# A d d e n d u m

Iowa Department of Transportation  
Office of Contracts

<b>B.O.</b>	<b>Proposal ID</b>	<b>Proposal Work Type</b>	<b>County</b>	<b>Project Number</b>	<b>Addendum</b>
356	00-000S-560	Dynamic Message Signs	Statewide	ITS-000-S(560)--25-00	19jun356.a01

MODIFIED SOST-17-11

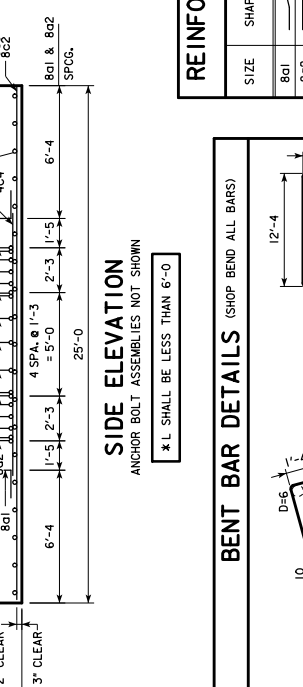
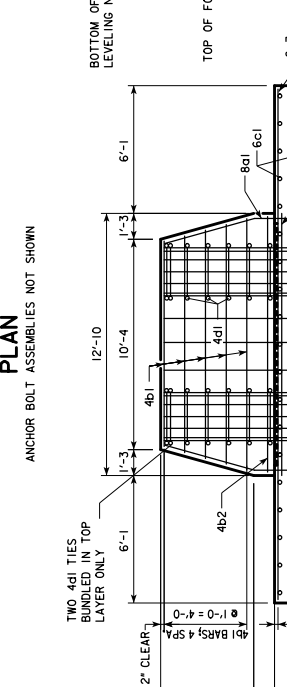
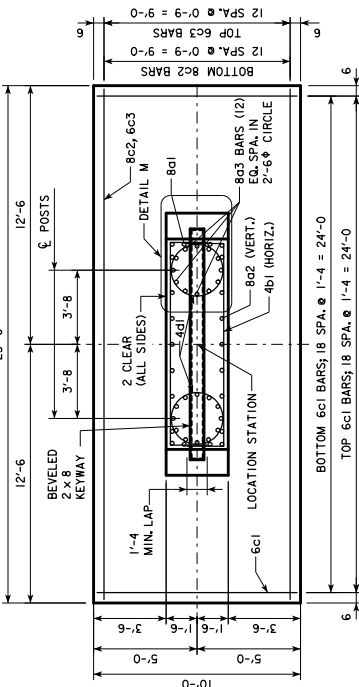
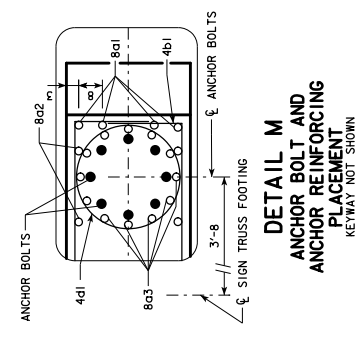
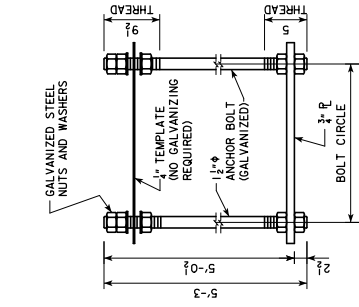
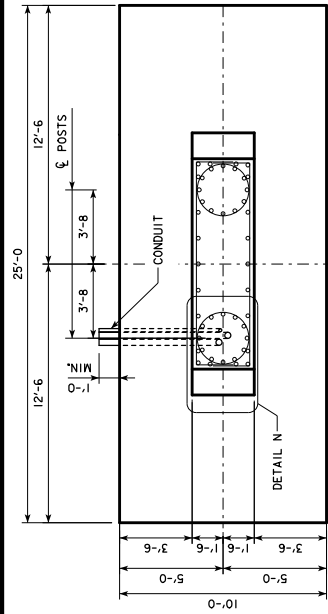
Steel Overhead Sign Truss Standard Sheet SOST-17-11

Replace SOST-17-11 with a modified SOST-17-11 sheet that includes a note stating that electrical conduit is required in footings supporting trusses with dynamic message signs. (See attached sheet.)

**FOR DMS TRUSSES ONLY**  
 ELECTRICAL CONDUIT IS REQUIRED IN FOOTINGS SUPPORTING TRUSSES WITH DYNAMIC MESSAGE SIGNS. SEE STANDARD SHEET SOST-17-11 FOR CONDUIT LOCATION DETAILS.

CONDUIT LOCATION DETAILS  
 SOST-18-11  
 50'-130' SPANS

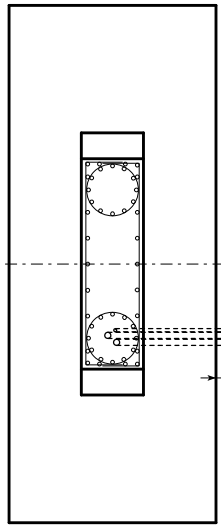
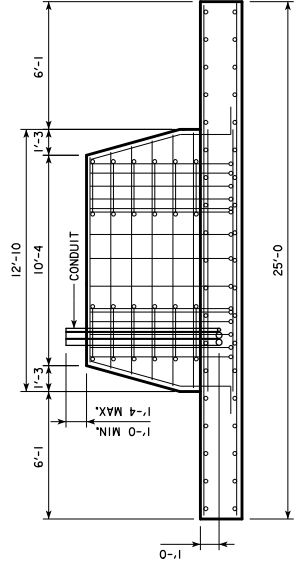
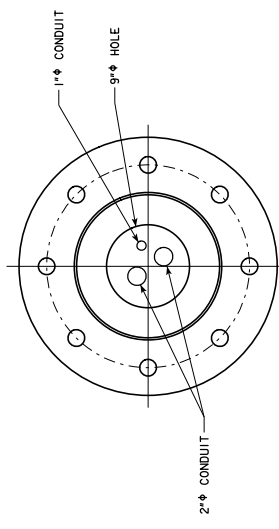
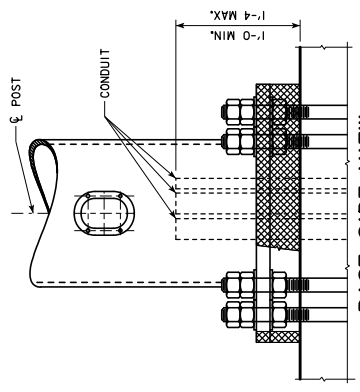
Steel Overhead Sign Truss Standard Sheet SOST-18-11

Add a new SOST-18-11 sheet that shows conduit location details in footings. (See attached sheet.)

FOR FOOTINGS SUPPORTING TRUSSES WITH DYNAMIC MESSAGE SIGNS, PLACE ONE CONDUIT AND TWO 2" CONDUIT WITHIN THE ANCHOR BOLT ASSEMBLY. THE CONDUIT SHALL BE PLACED WITHIN THE ANCHOR BOLT ASSEMBLY AND SHALL BE PLACED WITHIN THE ANCHOR BOLT ASSEMBLY. THE CONDUIT SHALL BE PLACED WITHIN THE ANCHOR BOLT ASSEMBLY. THE CONDUIT SHALL BE PLACED WITHIN THE ANCHOR BOLT ASSEMBLY.

**THIS SHEET FOR DMS TRUSSES ONLY**  
 ELECTRICAL CONDUIT IS REQUIRED IN FOOTINGS SUPPORTING TRUSSES WITH DYNAMIC MESSAGE SIGNS.
